ADDENDUM NO. 1

Q-881-24

**New Fire Alarm System for Storage & Land Fill Gas Collection Building at Halton
Waste Management Site, 5400 Regional Road 25, Milton, ON, L9E 0L2**

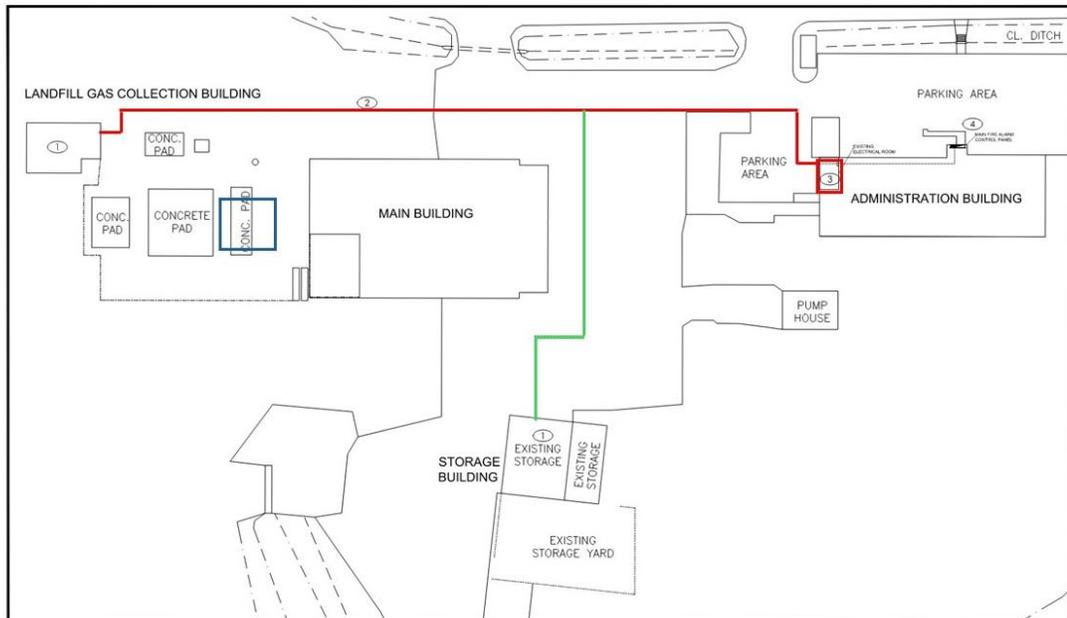
Question 2:

Please provide scaled site plan so we can estimate the distance between buildings. To calculate the run of underground conduit & cable required to complete the job.

Answer 2: We checked our CAD Drawings, and we estimate the distances from the Administration building to the Store building: 150 meters (the green line) and from the Administration building to the Gas Collection building: 180 meters (the red line). This is based on the path we have in the drawing; see below image. The contractor shall have his/her own number which will be verified by the consultant upon project completion. We do not know if the contractor will follow the same path due to the site conditions.

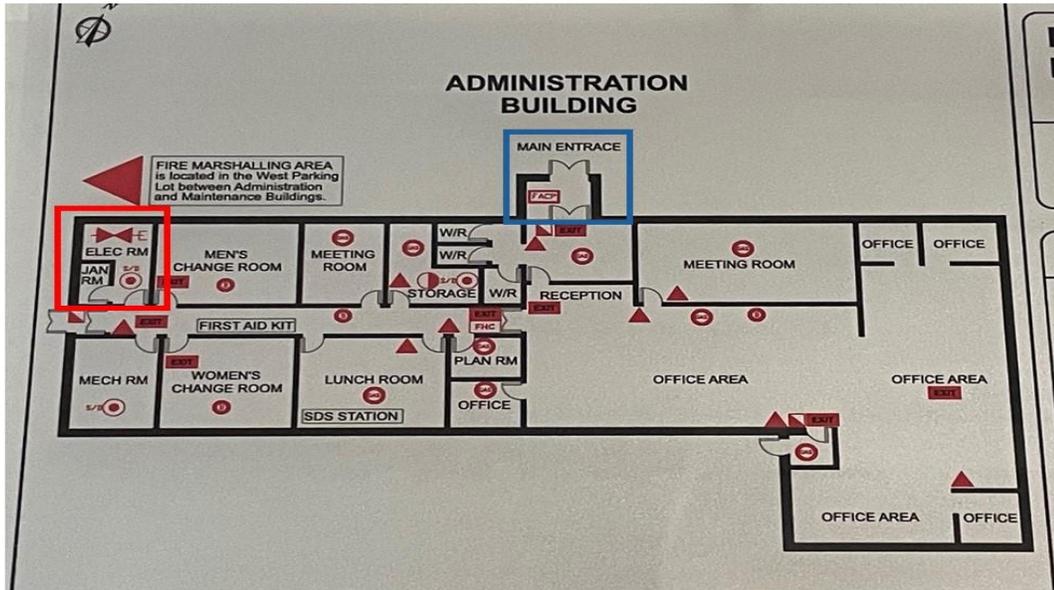
Question 5: Do we need to provide a new communication link between both the rooms to the main panel in the Admin room or the communication link is existing? If we need to provide new link, please provide the distance between the buildings to the admin room and the layout of admin room.

Answer 5: It is necessary to provide new communication links between the buildings (Storage and Gas Collection) to the Administration Building. The estimated distance is in answer 2. The links shall "enter" the Admin. Building through the electrical room (the RED square) and be routed to the through the ceiling to the main entrance vestibule where the existing FACP is located (the Blue square). See attached figure with the layout of the Admin Building.
